ADDENDUM #1

August 20, 2026

2027 Roof Replacement at
Grizzell Middle School
Dublin City School District Board of Education
8705 Avery Road
Dublin, Ohio 43017

Mays Project #: DOH43-010-03

Sheet Name:
PARTIAL ROOF PLAN - ALTERNATE #1

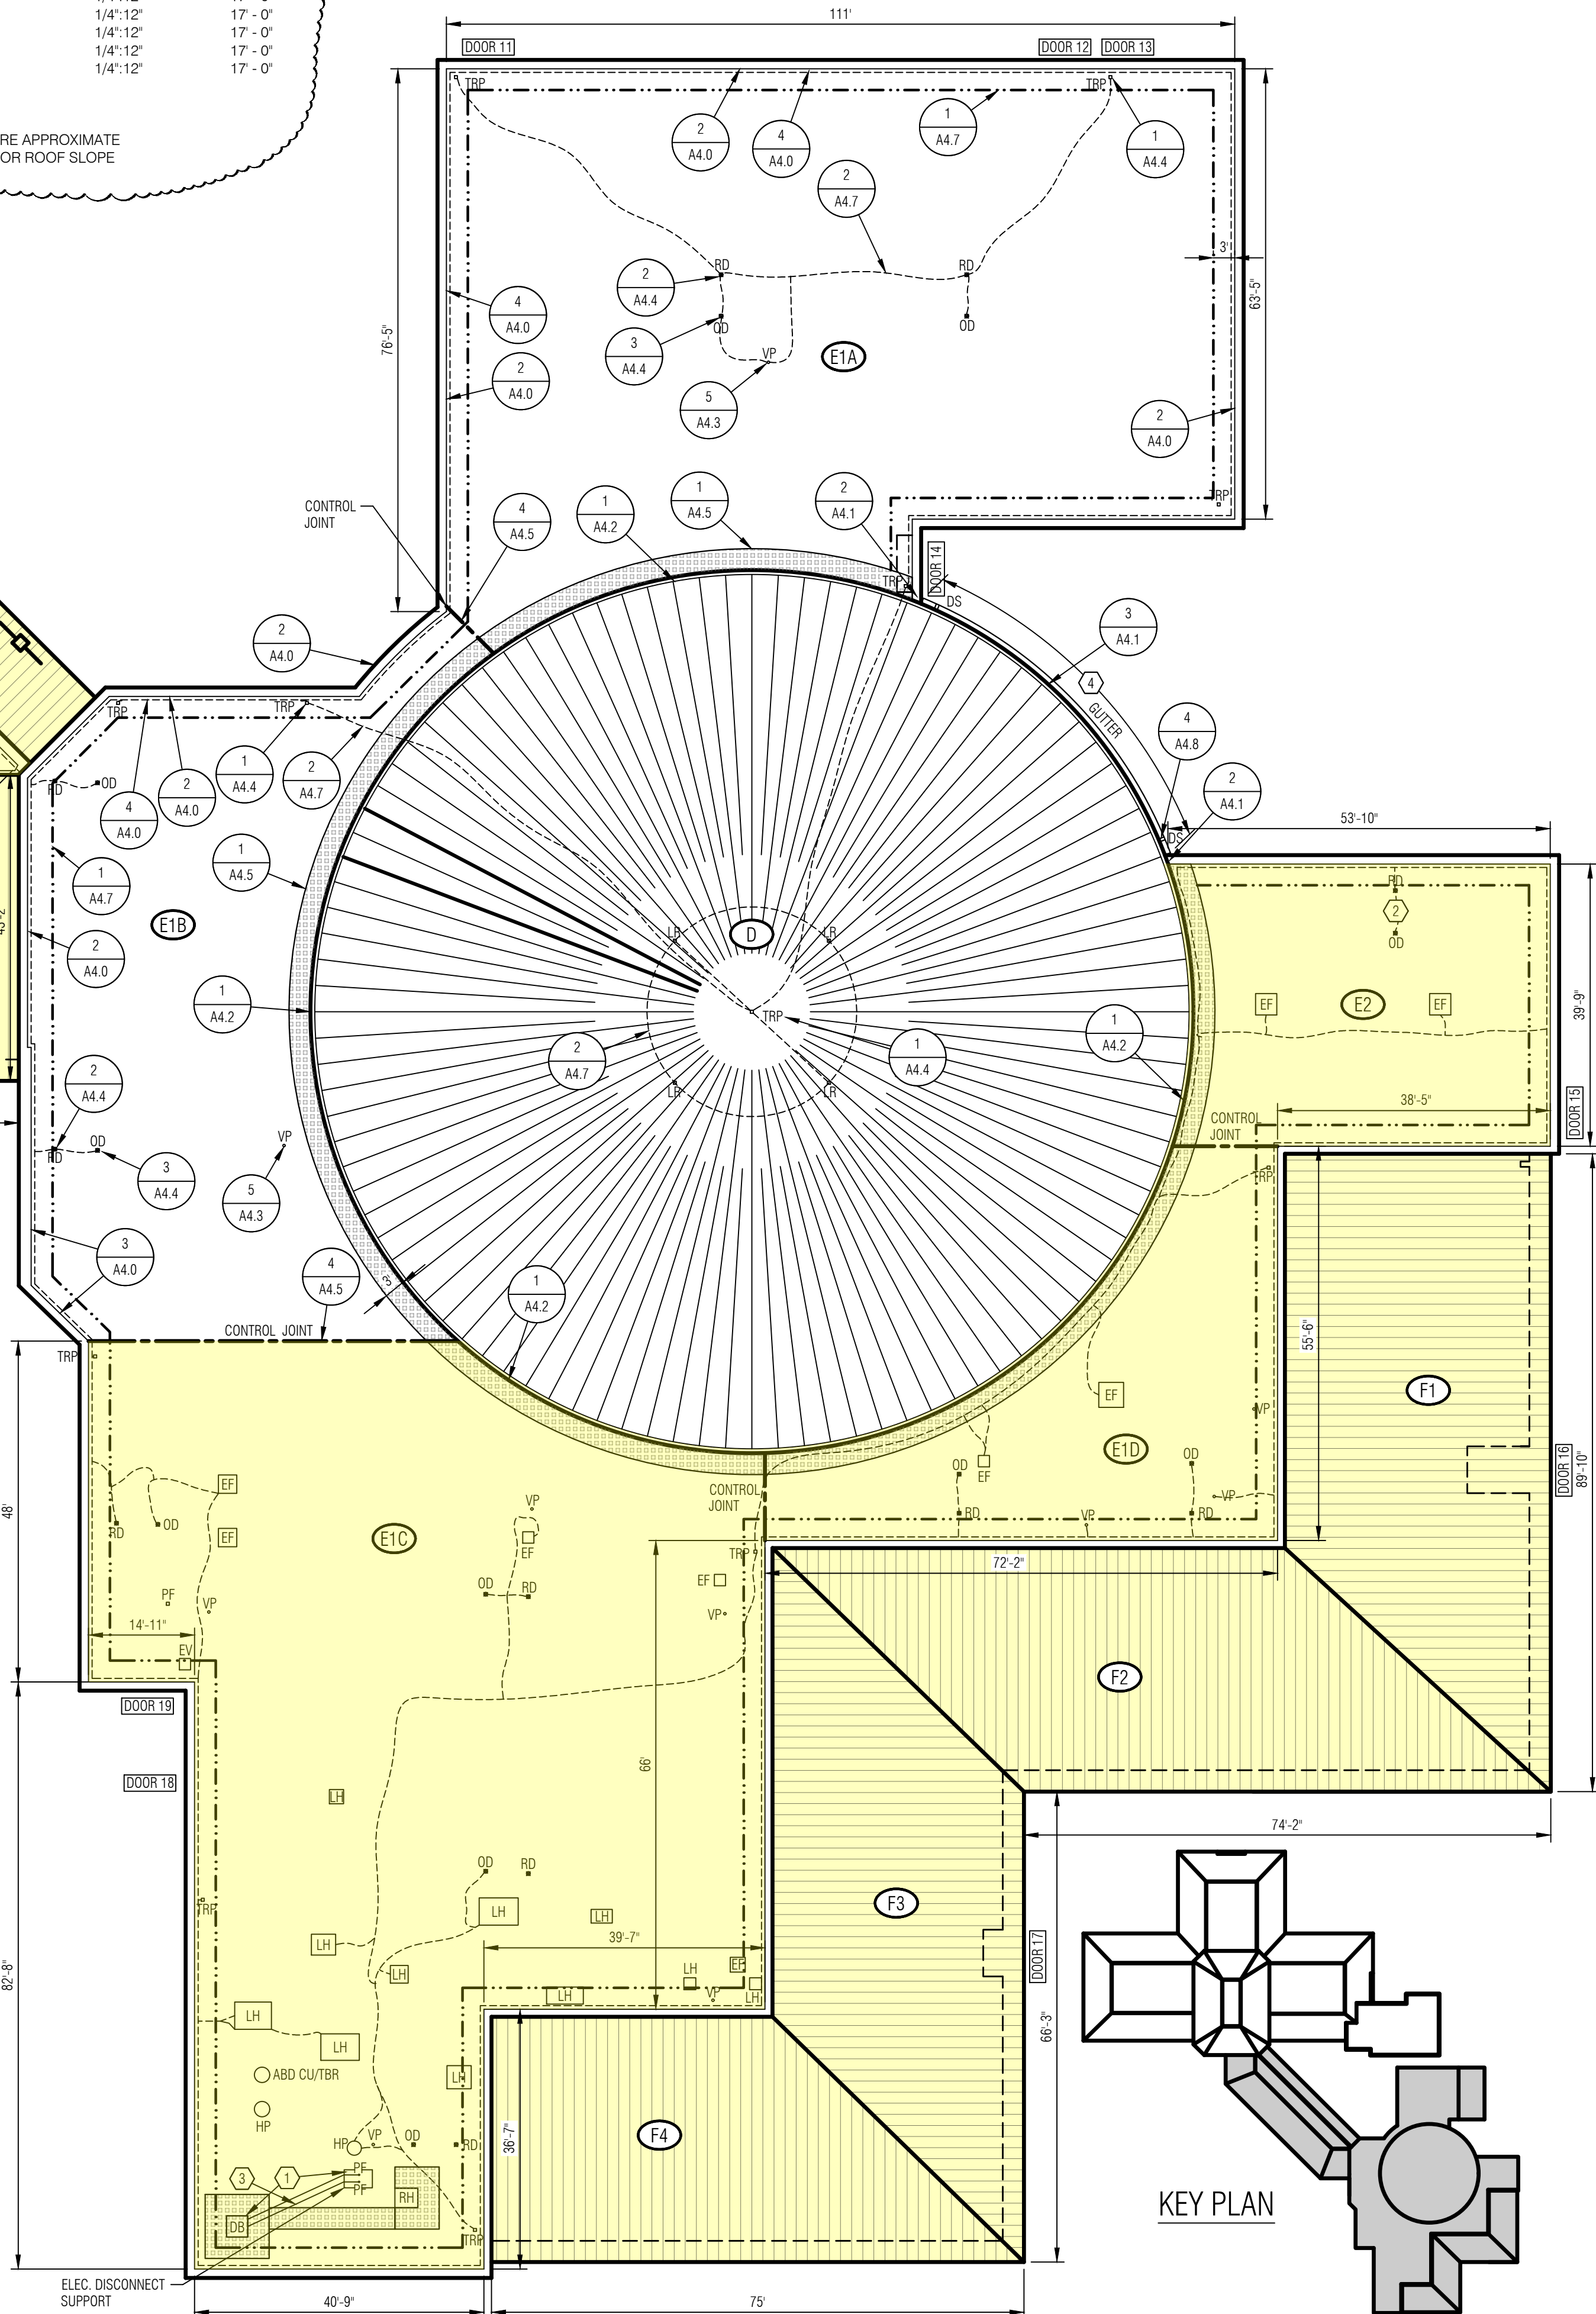
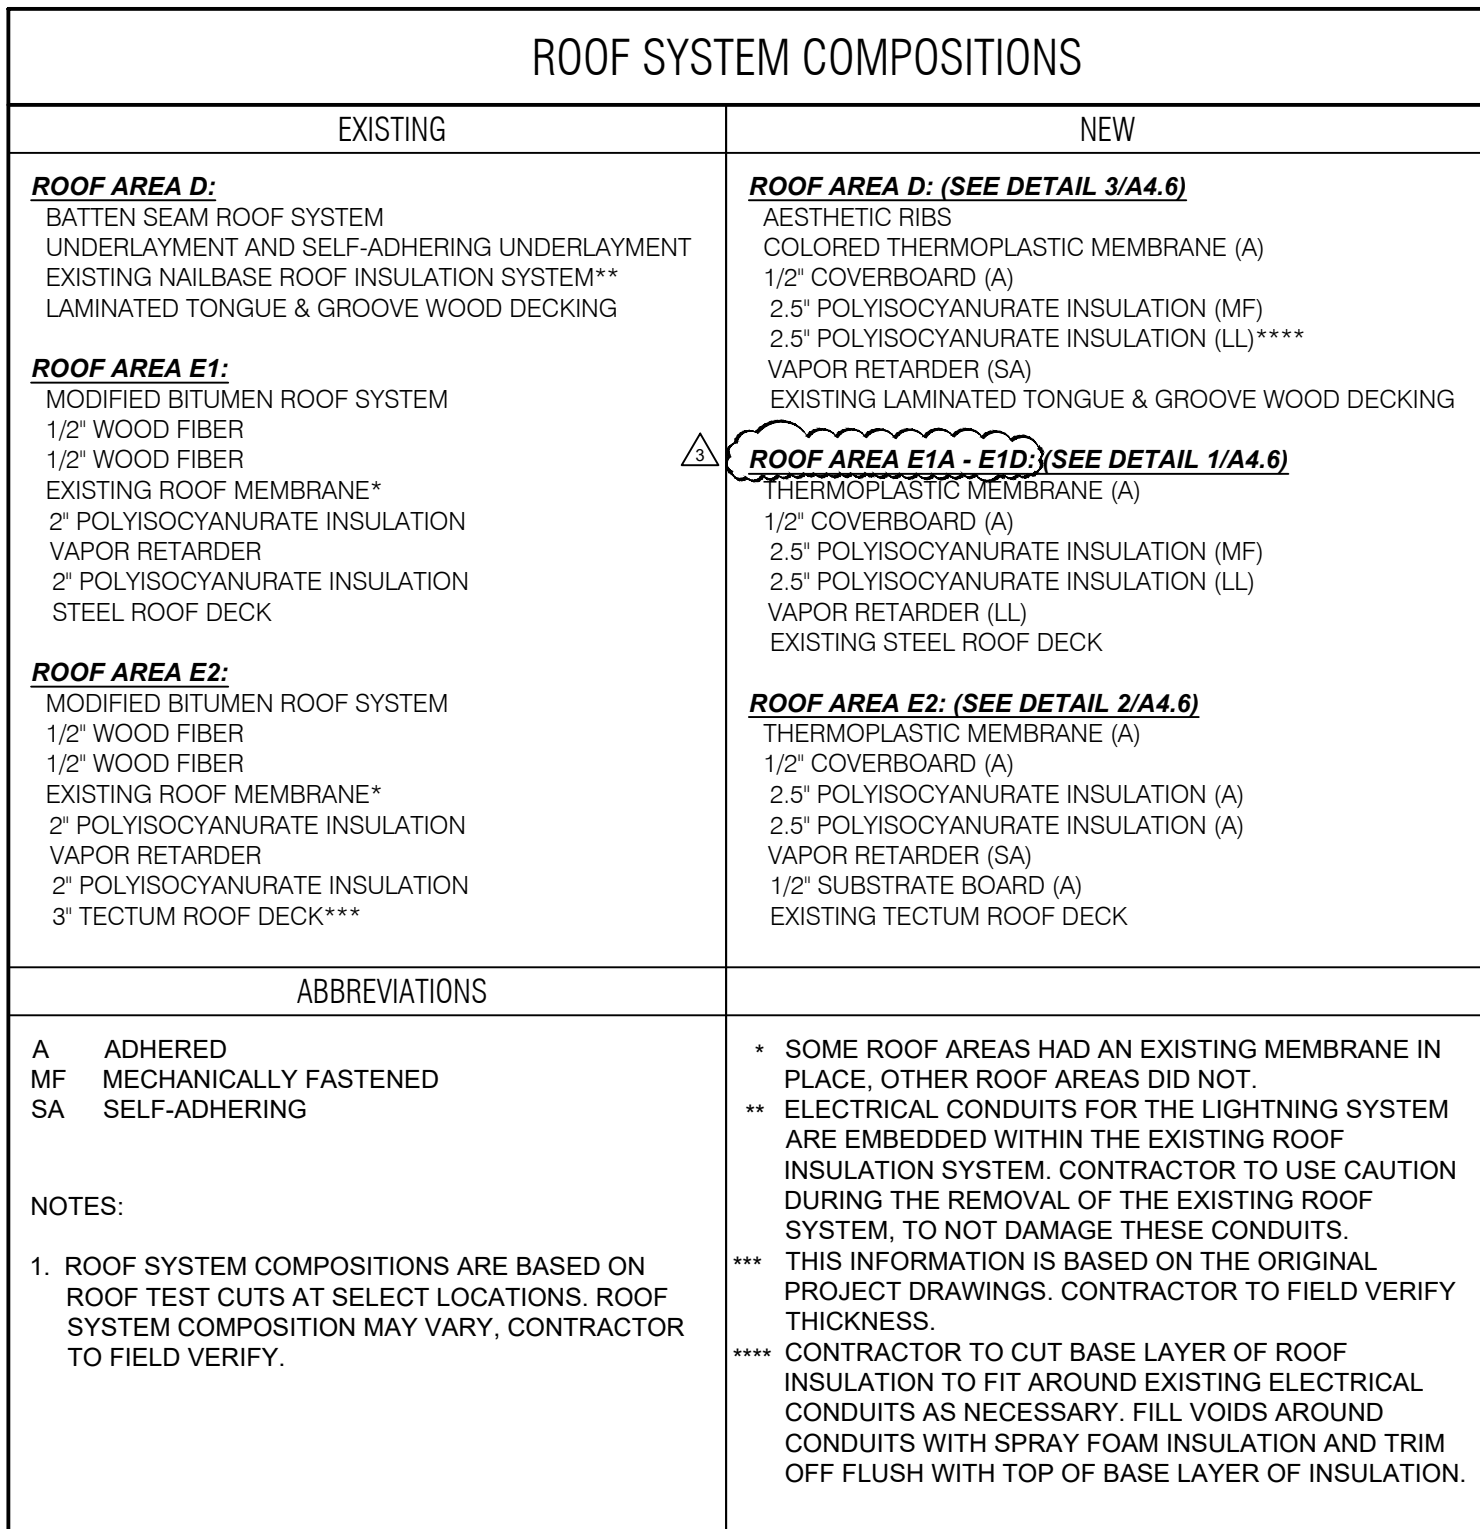
1. The bid due date has been changed to September 10, 2026.
2. The project is divided into a Base Bid Roof Area and an Alternate 1 Roof Area. A Revised Bid Form was provided and shall be utilized to submit a Bid for the project.
3. Roof Area E1 was broken down into Roof Areas E1a, E1b, E1c, and E1d to aid in referencing the Base Bid and Alternate 1 scope of work.
4. A project estimate was provided for the Base Bid and Alternate 1.
5. The Preliminary Schedule has been revised to reflect the revised Base Bid roof area.
6. Allowances were adjusted and added for Base Bid and Alternate roof areas.
7. The replacement of the existing roof hatch was added to the scope of the project.

PARTIAL WIND UPLIFT PLAN

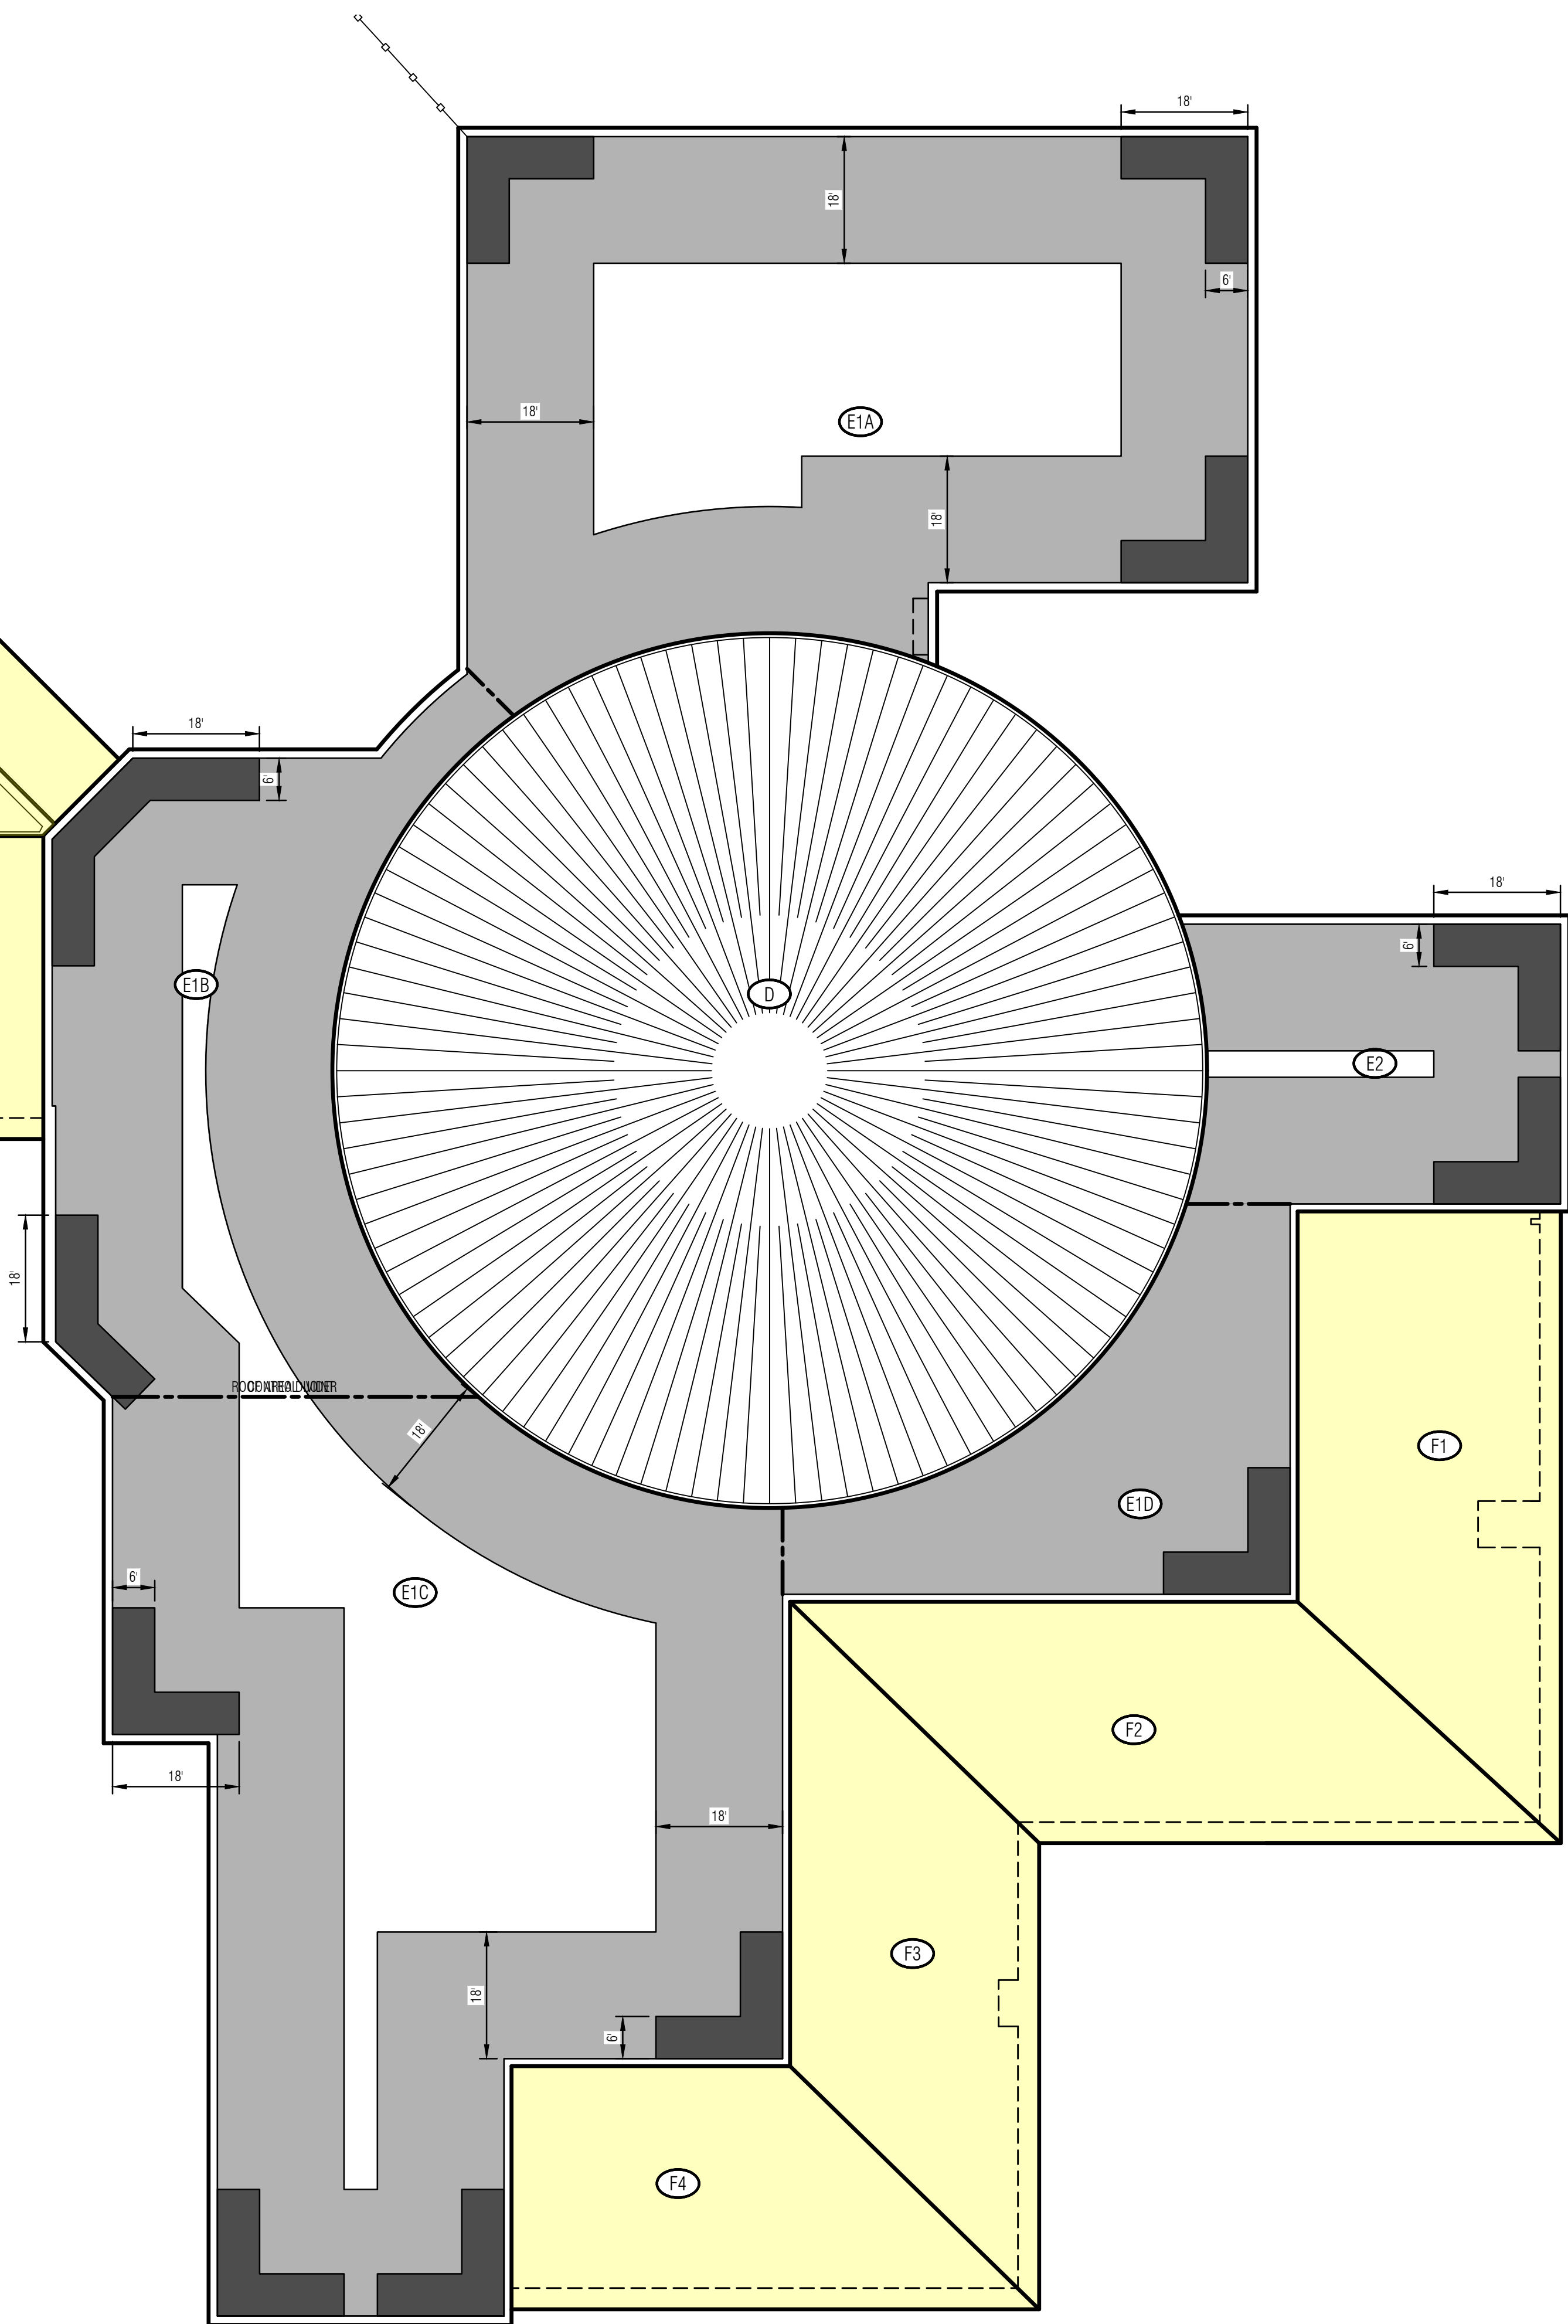
1. Drawing Sheet A1.0, A1.1, A1.2, and A1.3 shall be replaced or added with the attached revised drawing sheet.
2. Drawing Sheet A2.0 shall be replaced with the attached revised drawing sheet.
3. Drawing Sheet A3.0 shall be replaced with the attached revised drawing sheet.
4. Drawing Sheets A4.2 and A4.6 shall be replaced with the attached drawing sheet.
